RESPONSE TO REQUEST FOR ADDITIONAL INFORMATION

APR1400 Design Certification

Docket No. 52-046

RAI No.: 255-8285
SRP Section: 03.08.05 – Foundations
Application Section: 3.8.5
Date of RAI Issue: 10/19/2015

Figure 1 – Analysis Procedure for NI Basemat.

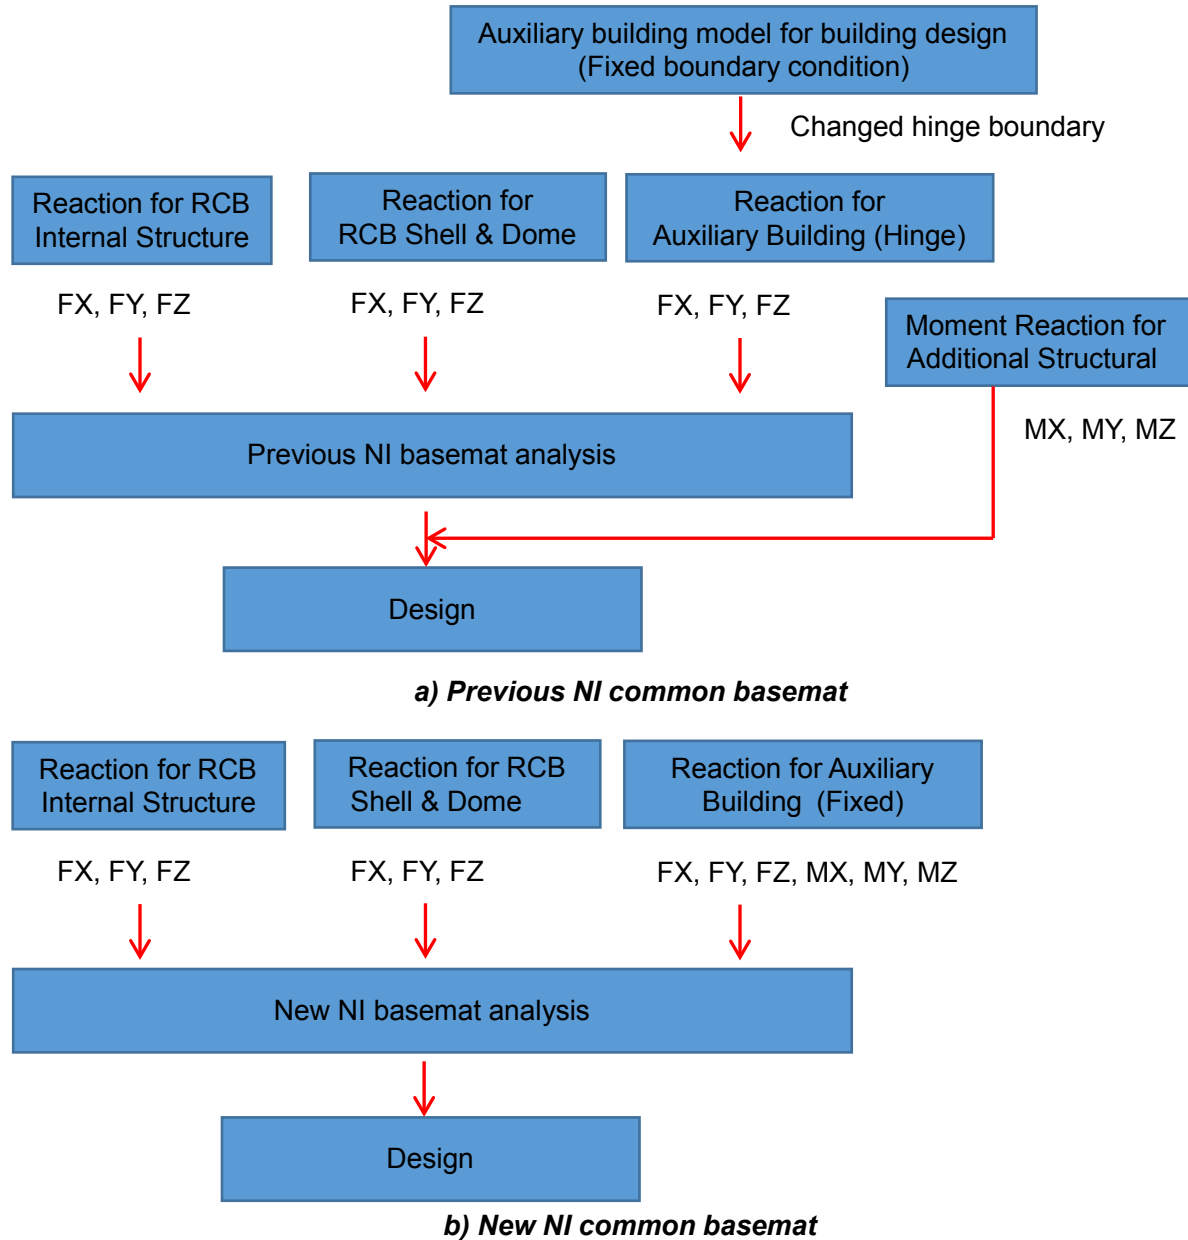
- (c) In DCD Tier 2, Appendix 3.8A, “Structural Design Summary,” subsection 3.8A.2.4.1, “Basemat,” the applicant stated that, “Since the rigid connection between walls and basemat is not simulated in the analysis model of the NI common basemat structure, the basemat of the AB is not subject to any moment that might occur. Therefore, the additional structural analysis was executed to obtain the magnitude of the moment transferred from walls and columns, which were subjected to lateral loads.” The applicant’s approach is not clear to the staff. Therefore, applicant is requested to explain, in sufficient detail, the analysis model, boundary conditions, soil springs, how loads were applied, what accelerations are applied, and why it appears that only additional moments from the walls and columns are applied, and not all forces from the superstructure above the basemat. If only forces from the superstructure were included, then the applicant is requested to explain how the forces from the basemat inertial response were considered in the seismic analysis. The applicant is also requested to explain whether the seismic analysis of the AB basemat was performed separately, or was considered in the same NI concrete basemat model and analysis described in DCD Section 3.8A.1.4.2 used to obtain the member forces.

As shown Table 1, the reaction forces (FX, FY, FZ) from individual RCB Shell &Dome and internal structure analysis were directly applied as input loads at the top of NI common basemat for the NI common basemat analysis. However, for the auxiliary building, the previous NI common basemat analysis used transitional forces and rotational moments, which were calculated separately. In order to minimize confusion in

the structural analysis, the new NI basemat analysis used 3- transitional and rotational moments from the auxiliary building analysis, as shown in Figure 1.

In order to compute the reaction for auxiliary building analysis, the boundary condition was changed to a hinge support, as shown Figure 1-a). Therefore, only forces from auxiliary building were applied for NI common basemat analysis. The

additional structural analysis was performed to consider out-of-plane moments transferred from superstructure wall to basemat.

In the additional structural analysis, the individual auxiliary building model is used. Applied loads, including seismic acceleration to the superstructure model, are identical to the loads used in the individual auxiliary building structural analysis. For the boundary condition of the additional building analysis, the degree of freedom at the support nodes is only released for rotation to transfer out-of-plane moment to the basemat, soil springs are not considered. This causes out-of-plane moments and forces in the shell elements at basemat. Therefore, both were used in the basemat design. However, the purpose of the additional analysis is to account for the basemat global analysis and capture the local effect on the basemat.
